FOR THE MEETING OF: September 16, 2021
AGENDA ITEM: 5.b

CASE NO.: Modification of Historic Design Review Case No. HIS19-19MOD1

APPLICATION SUMMARY: Proposal to modify a previous historic design review approval (HIS19-19) to modify the originally approved window type on the upper stories of the proposed new seven story hotel.

LOCATION: 195-197 Commercial Street SE (See Attachment A)

1 TYPICAL FACADE BAY
3/32" = 1'-0"

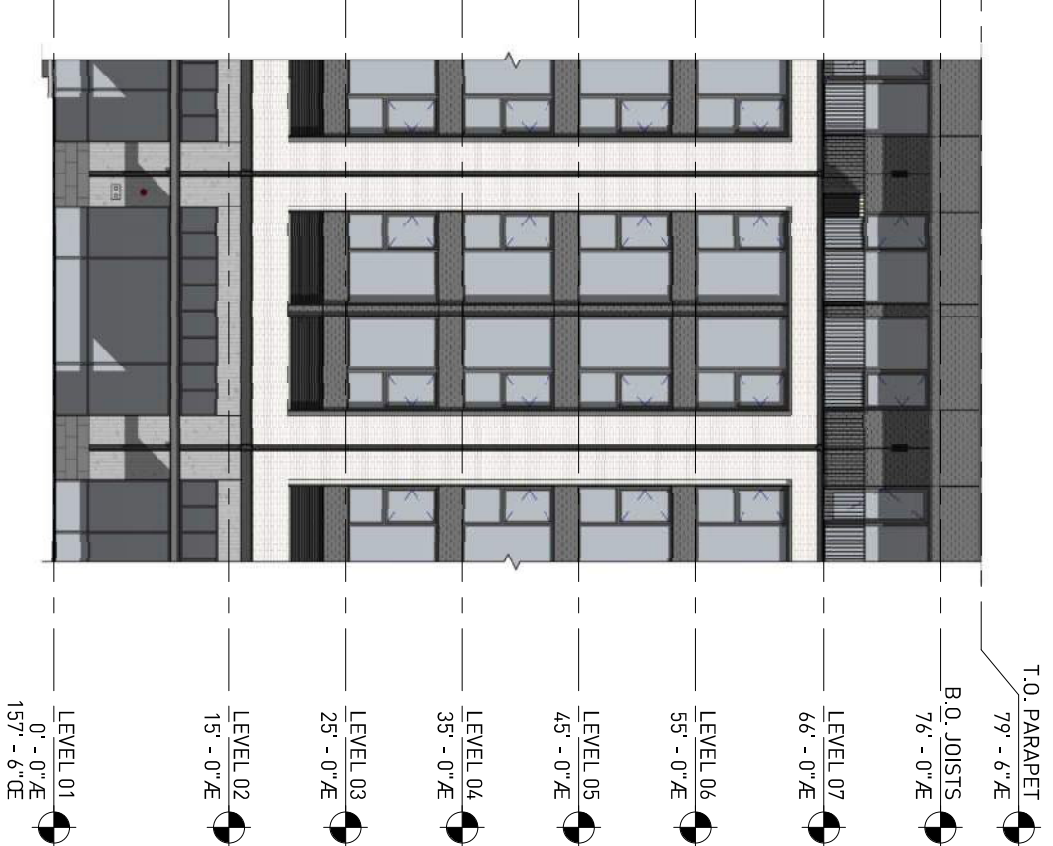
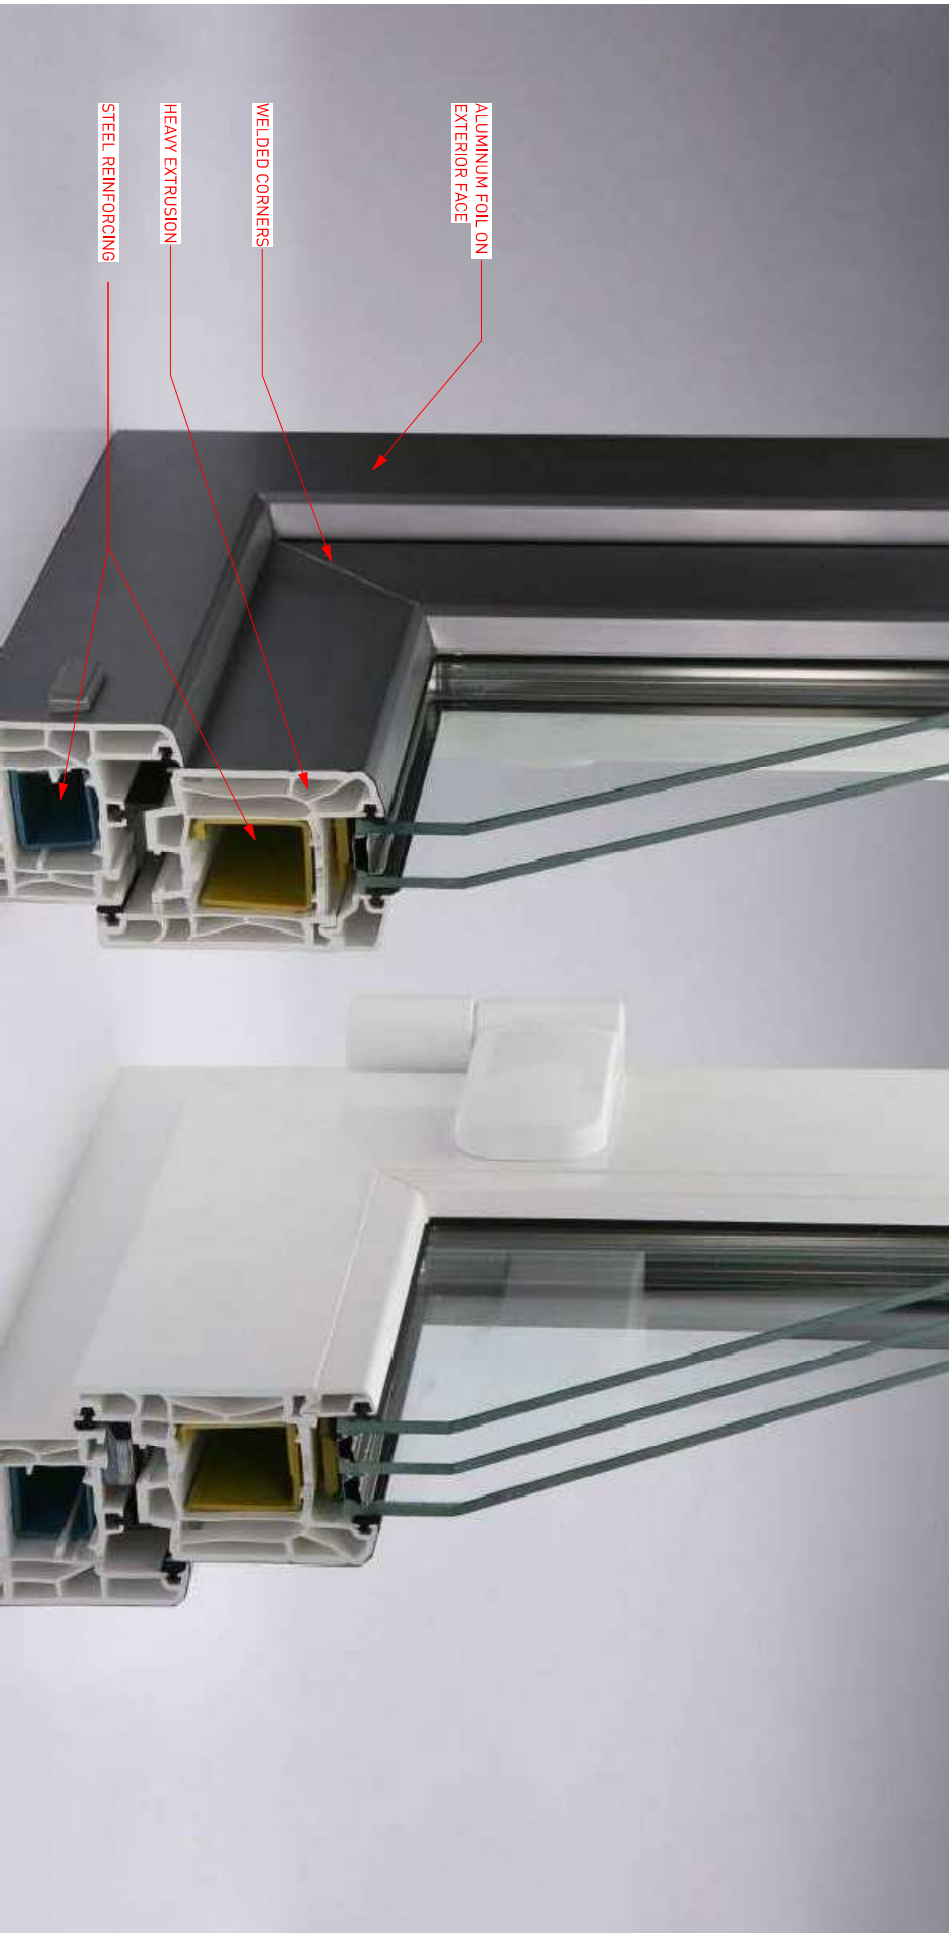
As part of this application, we are asking the historic landmarks commission to approve one change to the previously approved design. At levels three to seven, we are proposing to use vinyl windows with a dark grey aluminum cladding on the exterior face, in lieu of the previously aluminum clad wood windows. The difference to the pedestrian at ground level will be imperceptible. The lowest window sill will be 25' above the sidewalk. The same material, aluminum, will be visible on the exterior face. The aluminum has a factory applied color. While not expected to be necessary, the windows could be painted in the future if necessary.

The proposed Innotech windows are a commercial grade vinyl window, with steel reinforcing and welded corners, ensuring a long life for the product. The windows will have dark gun metal color on the exterior face, in lieu of the previously aluminum clad wood windows. The color of the windows will match that of the adjacent Equitone panels, limiting the number of colors on the façade.

The difference between the previously approved and the new windows will be imperceptible to the pedestrian at the ground level. The lowest window sill will be 25' above the sidewalk. The same material as previously proposed—aluminum—will be visible on the exterior face.

Finding: The proposed design of the new Innotech commercial grade vinyl windows will replicate the design of the previously approved aluminum clad wood windows. The portion of the windows on the exterior façade will be clad in aluminum. The glazing for each floor (3-7) follows a typical pattern for the facades fronting Commercial and Trade Streets (Eastern and Southern facades). Within each façade there are four vertical columns, three of which are framed in brick. The vertical column above the main entry on each façade is recessed and not framed in brick. The proposed glazing follows an A:B:B:A pattern, where "A" windows project the appearance of a 1 over 1 double hung window with a metal frame. The "B" windows are a simple large one light metal framed fixed casement. The building is designed where each floor is separated by a band of metal panels which are grouped and recessed in a pattern that emphasizes the verticality of the building. While the windows are not of a form typically found on historic contributing buildings, the overall design of the proposed building generally reflects the tripartite form of historic contributing buildings in the district with an articulated base, column, and capital, with the patterning of the windows forming the vertical 'column.'
